Re:	Project Name:	Circle K – Revised Major Final Site Plan
	CH Project No.:	16-0804
	Project Number:	P166-002
	Application Type and Number:	D059 201700358
	Report Number:	2017_1207_C166-002_DRT_Staff_FINAL.docx

Please accept this response letter addressing comments provided by staff on December 7<sup>th</sup>, 2017.

## A1.2

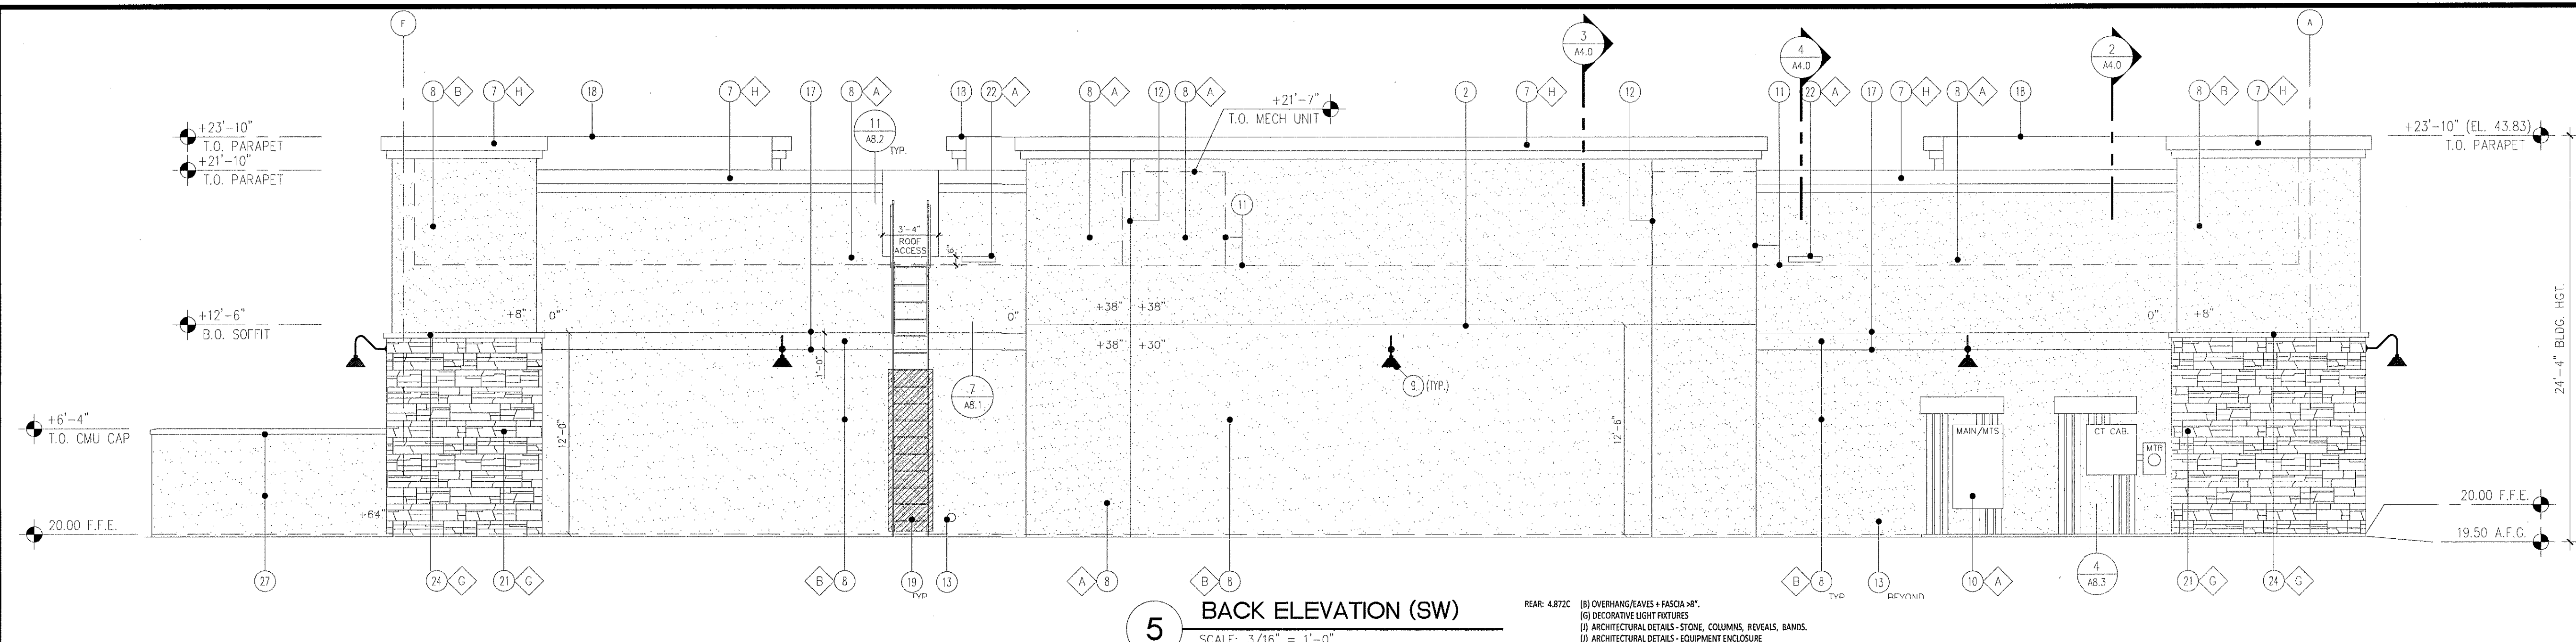
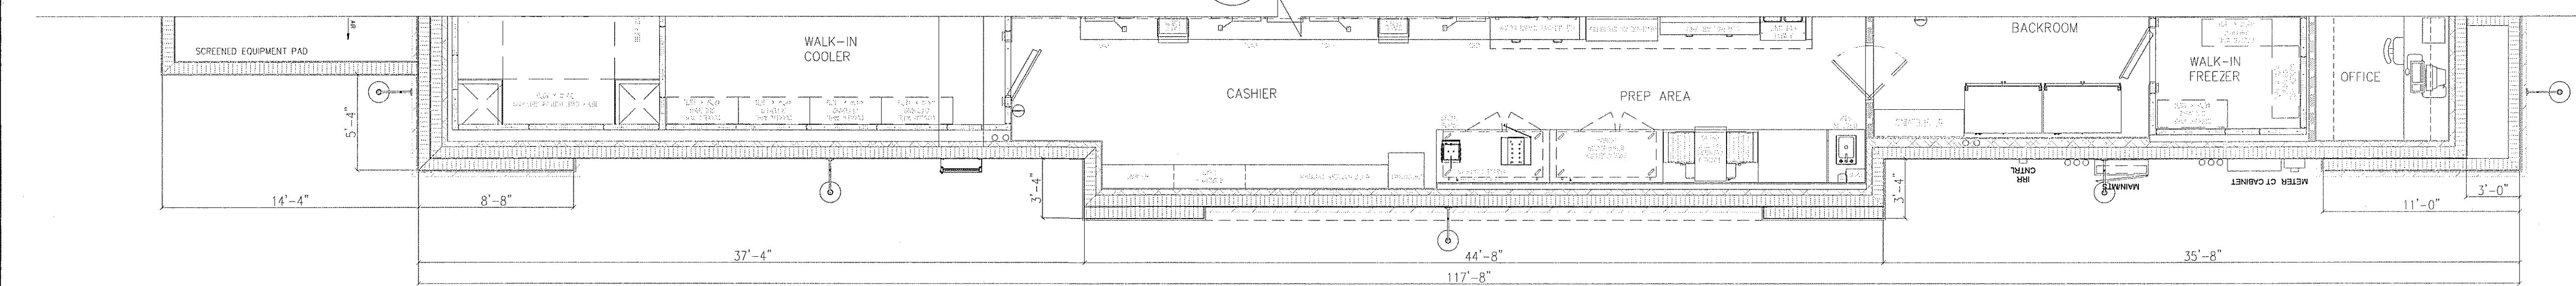
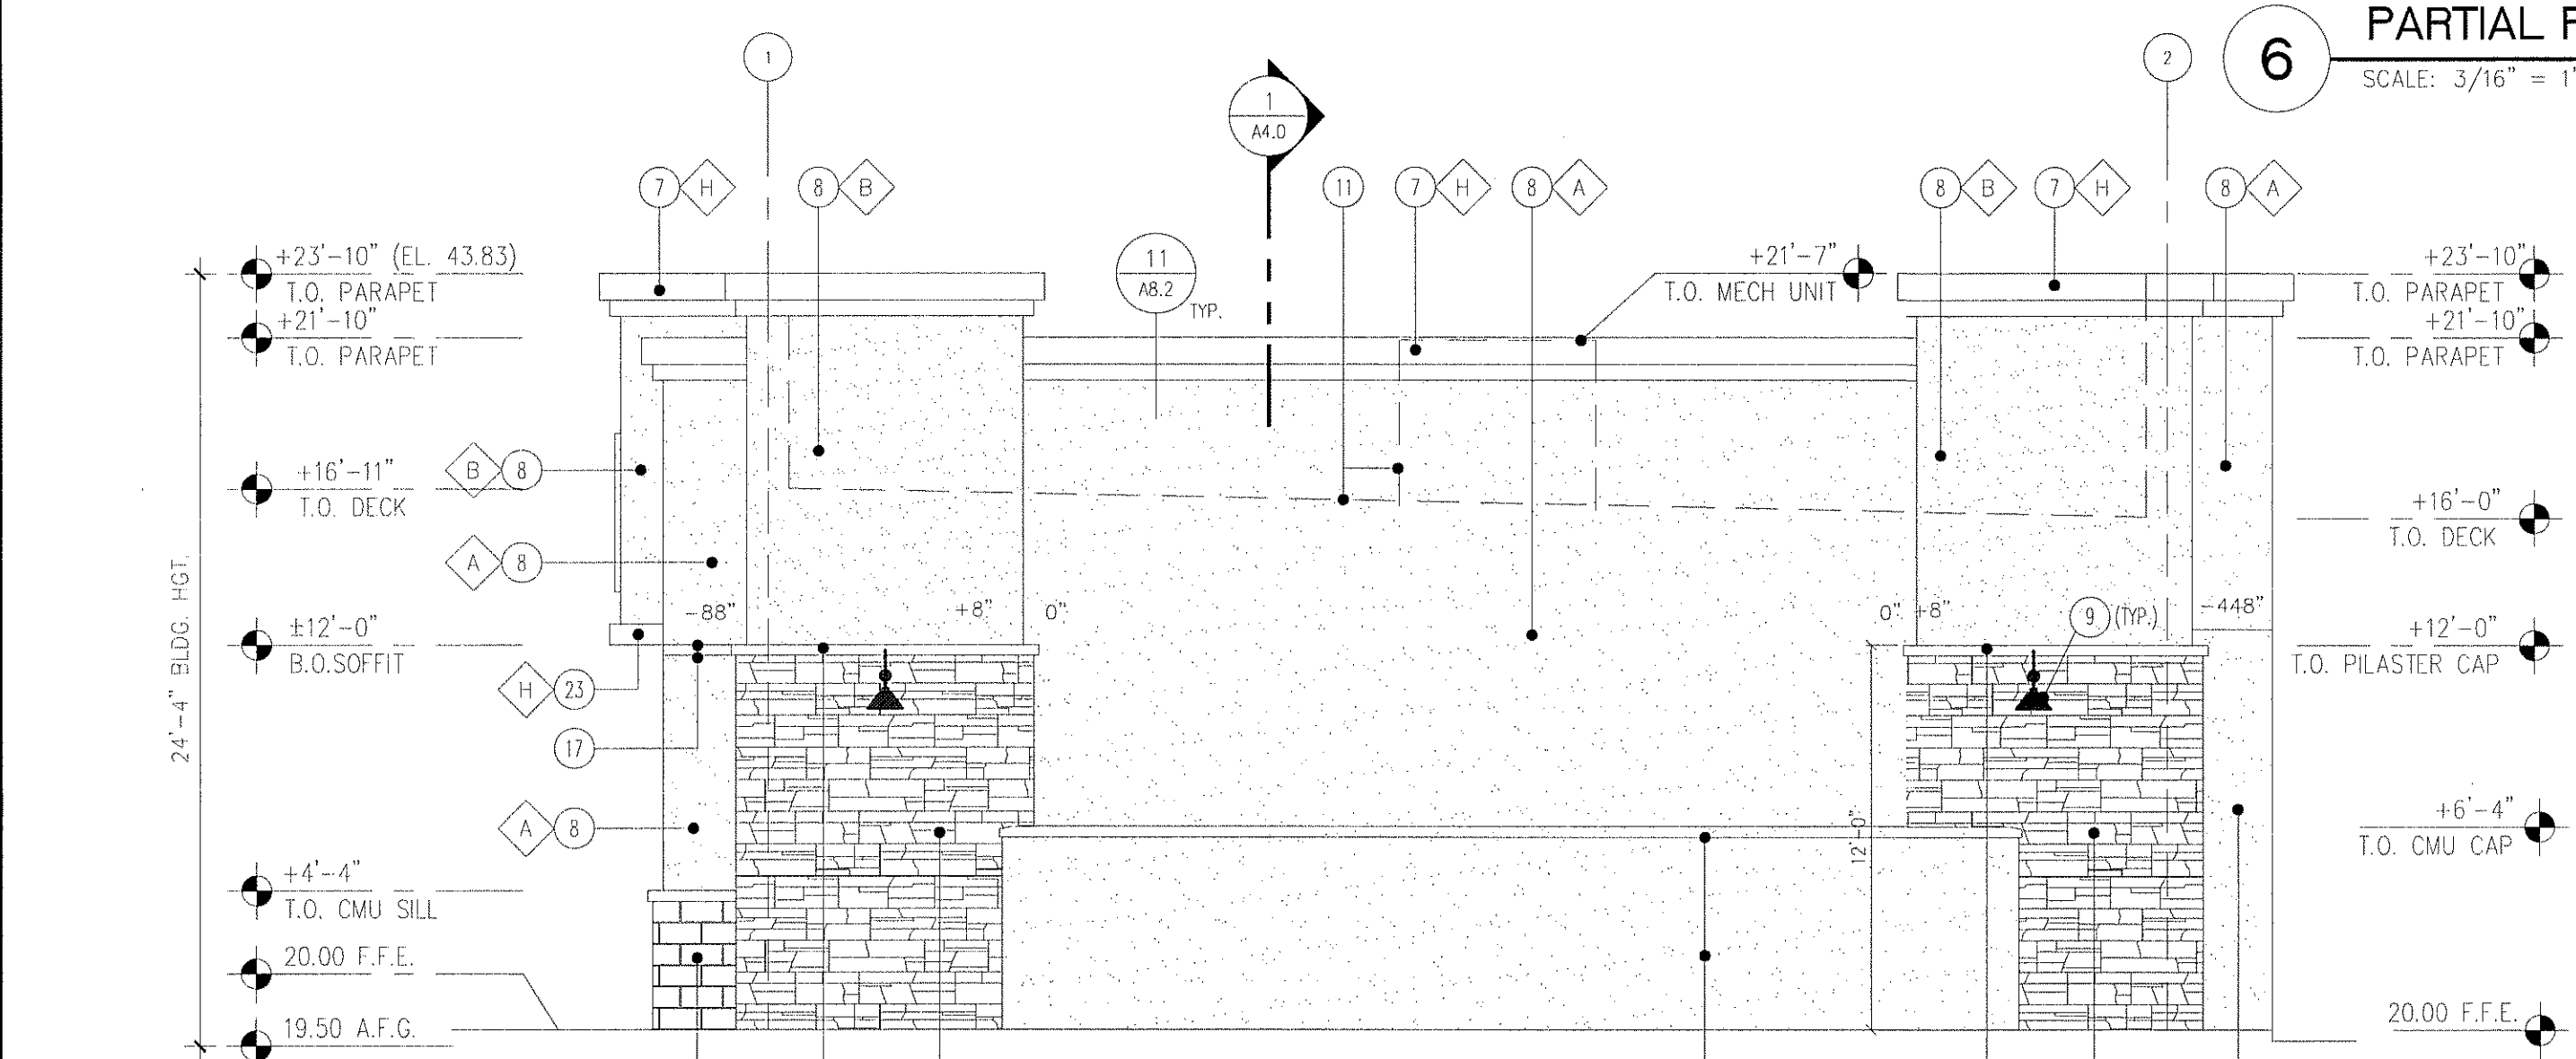
The building elevations shown on Sheet A2.1 do not appear to utilize the required methodology. Please

re-dimension the proposed maximum building height and provide it in the site plan data.

The Northeast and Southeast Elevations are considered the primary façades. The Northeast elevation has a continuous wall plan that exceeds 100' linear. Please show all the dimensions on the floor plan and Northeast elevation in order to demonstrate compliance with this section.

**Applicant Response:** The building elevations have been revised and the “average Finished Grade” at the perimeter of the building noted and building height dimensioned from the AFG as well as the Finished Floor Elevation (FFE). The AFG has also been noted in the Site Plan Data.

[Applicant Response: The floor plan and exterior elevations have been revised to reduce the wall plane that exceeds 100'. The 3 ft x 4ft columns have been revised to 3 ft x 8 ft, and dimensions provided to show compliance.](#)

**Figure 2**  
Project % Assignment - Outbound  
**Circle K**

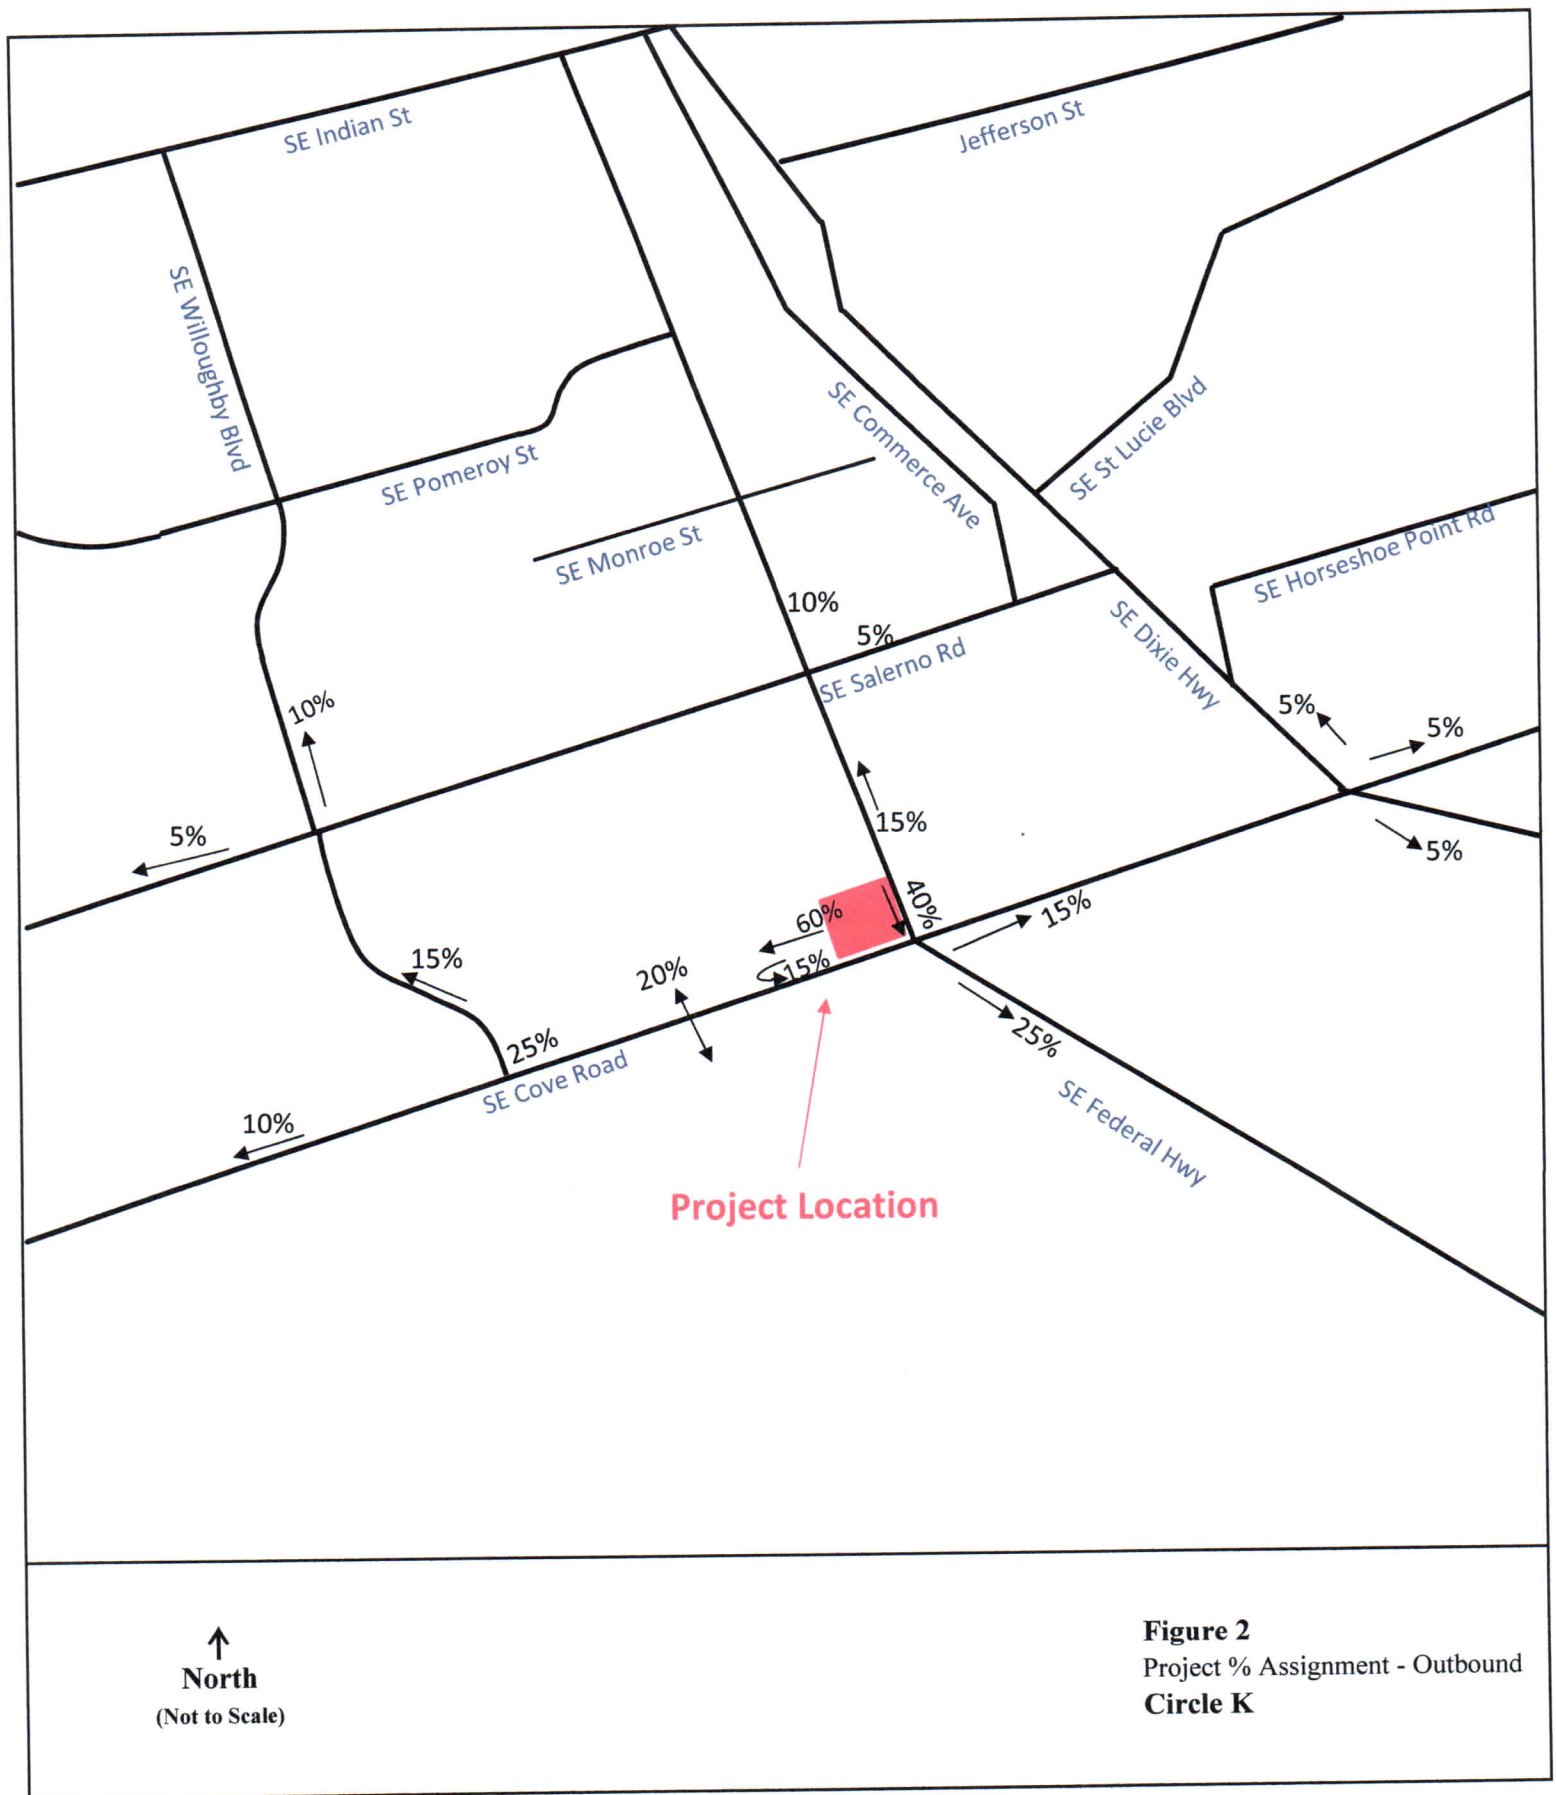
1. Project Assignment section should narrate to staff what is being analyzed, for example, PM entering or PM exiting. Estimated project trip generation and assignment, considering pass-by and internal capture, on a peak hour peak direction basis [Martin County, Fla., LDR Article 5, Division 3, Section 5.64.C (2009)].
  - a. Figure 2 Project % Assignment needs to be updated to reflect comments above and remove unnecessary assignments. Update Table 2 as necessary.
  - b. Remove/reduce U-turn movement on SE Cove Road from Appendix C.

[Applicant Response: Figure 2 Project % Assignment has been updated and unnecessary assignments has been removed. \*\*Table 2\*\* has been updated as well. The U-turn movement on SE Cove Road from \*\*Appendix C\*\* has been removed.](#)
